### AMENDMENTS TO THE DRAWINGS

Attached hereto are Figs. 1 and 7 Replacement Sheets of drawings that comply with the provisions of 37 C.F.R. § 1.84. The drawings incorporate the following drawing changes:

FIG.1  
Prior Art

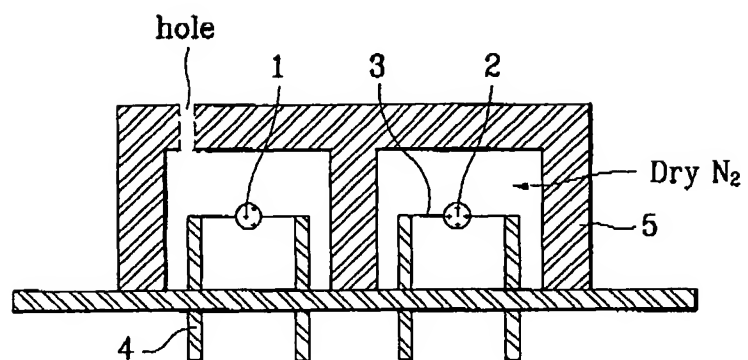
Fig. 1 is identified as prior art and Fig. 7 has been amended to show the thermal conductive film 55a.
